City of Detroit
Inter-Departmental Communication

RE: Petition #1078-revised
Request for Conversion To Easement Of Woodward, Philadelphia, John R., And
Euclid

CONVERSION TO EASEMENT
 PART OF PUBLIC ALLEY, 20 FT. WD.
 BEHIND PROPERTY LOCATED AT
 30 E. PHILADELPHIA
 IN THE BLOCK BOUND BY
 EUCLID AVE., WOODWARD AVE.,
 PHILADELPHIA E. AVE. AND JOHN R. ST.

CITY OF DETROIT CITY ENGINEERING DIVISION SURVEY BUREAU	
JOB NO.	01-01
DRWG. NO.	X 1078

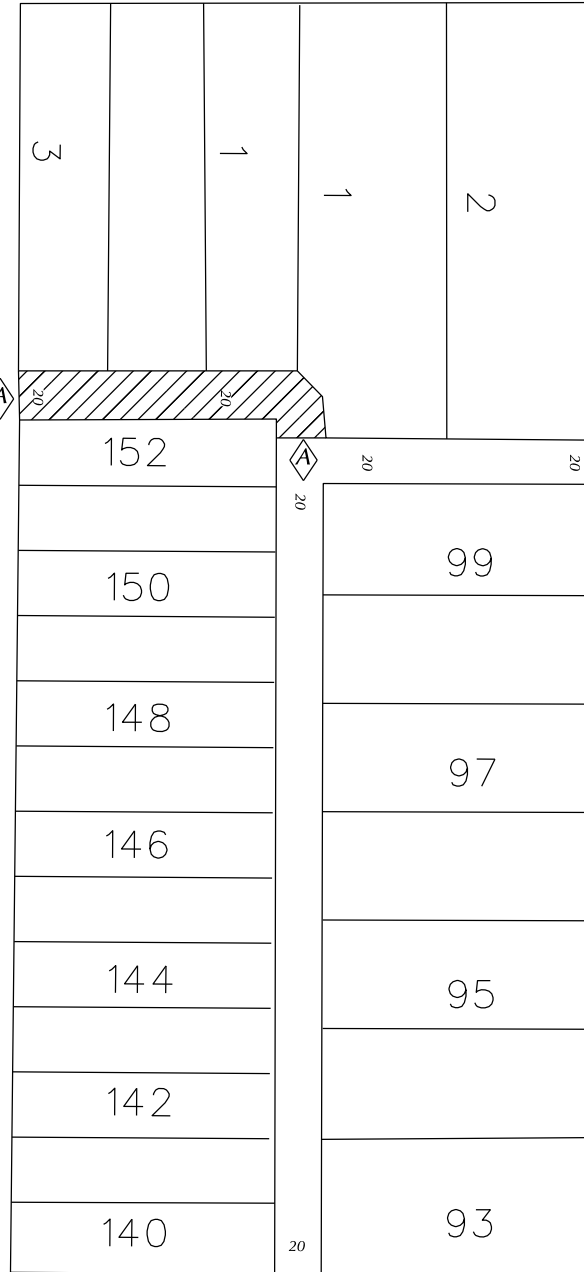
The above petition received by this office has been reviewed. With regard to DWSD's interests, our comments are as follows, our records indicate that there is a sewer in the right of way DWSD has no objections to the conversion to easement provided that the attached provisions for conversion to easement are followed.

1. An easement, the full width of the existing right of way, is reserved for the Detroit Water and Sewerage Department for the purpose of installing, maintaining, repairing, removing, or replacing any sewers, water mains, fire hydrants and appurtenances, with the right of ingress and egress at any time to, and over said easement for the purpose above set forth. Any proposed fencing across the easement must have a gate installed to permit access for DWSD forces. The gate shall remain unlocked 24 hours a day, unless a guard is stationed near the gate to allow the Detroit Water and Sewerage Department ingress and egress at any time. The minimum dimensions of the gate or gates shall provide 15 foot vertical and 13 foot horizontal clearances for freedom of D.W.S.D. equipment movement.

2. Said owners of the adjoining property, for themselves, their heirs and assigns, agree that no building or structure of any nature whatsoever, including fences, porches, patios, balconies, etc., shall be built upon or over said easement, or that no grade changes or storage of materials shall be made within said easement without prior written approval and agreement with the Detroit Water and Sewerage Department.

3. If at any time in the future, the owners of any lots abutting on said conversion to easement shall request the removal and/or relocation of the aforementioned utilities in said easement, such owners shall pay all costs incident to such removal and/or relocation. It is further provided that if sewers, water mains, and/or appurtenances in said easement shall break or be damaged as a result of any action on the part of the owner, or assigns, then in such event, the owner or assigns shall be liable for all costs incident to the repair of such broken or damaged sewers and water mains, and shall also be liable for all claims for damages resulting from his action.
